## **Technical Bulletin**

No. 81-9059-0431-0 A

Title: Audio Input Cable Connector Installation

Products: Lynx, RM4000, RM5000 Audio Routing Switchers

Figure 1. Audio Input Cable Connector Installation

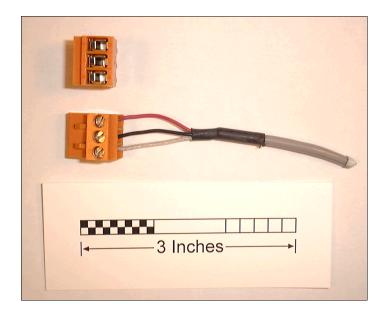
Additional information is needed to install the audio input cable connectors for the products listed above.

Audio input cables are terminated with a 3-contact plug (PESA Part. No. 81-9029-0607-2) as shown in Figure 1. The connector contacts are not marked so the connector should be wired in accordance with Table 1.

Fig. 1 Position	Wire Color	Function
Top	Red	Audio High
Center	Black	Audio Low
Bottom	Shield	Shield
